RESPONSE TO OFFICE
ACTION DATED DECEMBER 12, 2003

Atty. Docket No. 100-13202
(P04776-C2)

09/660,386

APPENDIX

FIG. 1

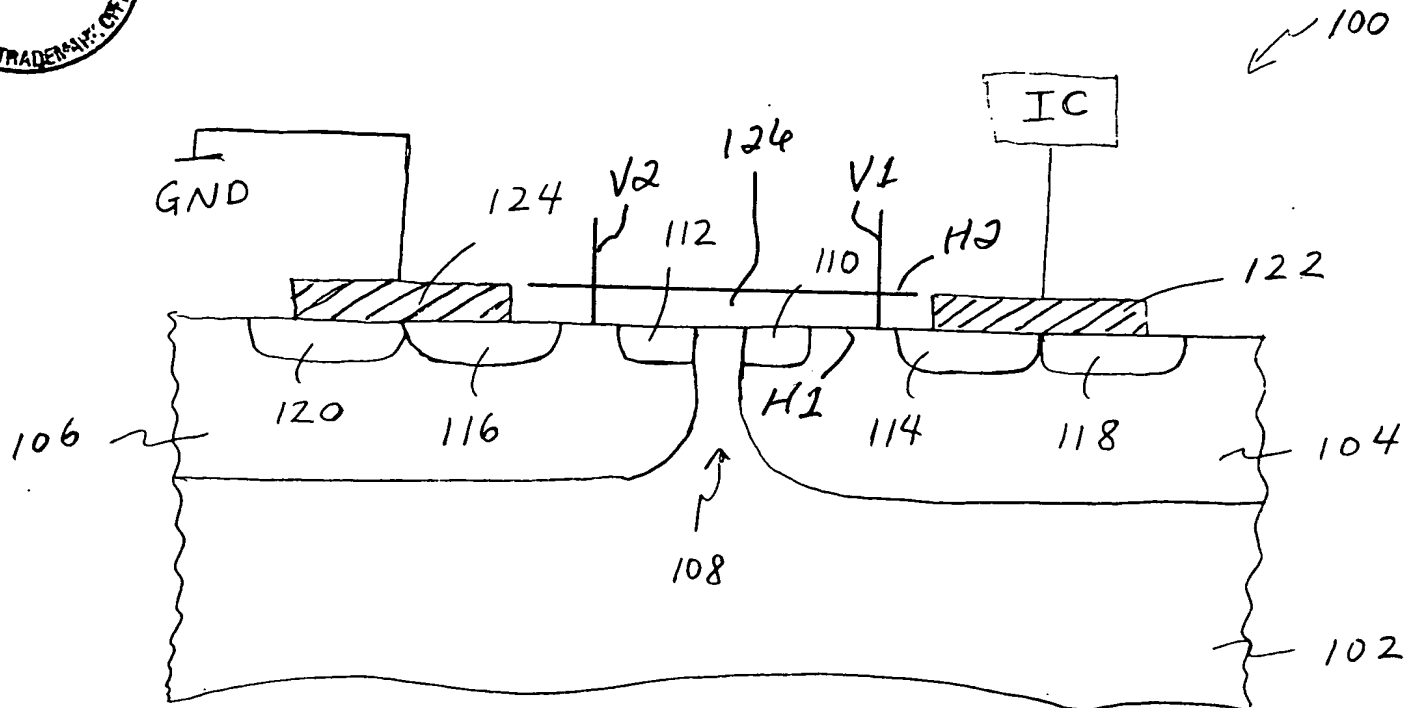
The Examiner objected to the drawings because FIG. 1 does not show the device region of the claims. FIG. 1 has been amended, as shown in red on the attached annotated marked-up drawing sheet of FIG. 1, and as shown in the attached replacement sheet of FIG. 1, to define a device region 126. In addition, the specification has been amended to define the device region 126. No new matter has been added. The replacement sheet of FIGs. 1 and 2, which is included in the Appendix along with the annotated marked-up drawing sheet of FIGs. 1 and 2, is to replace the formal sheet of FIGs. 1 and 2 mailed on September 4, 2002 and received by the Office on September 9, 2002.
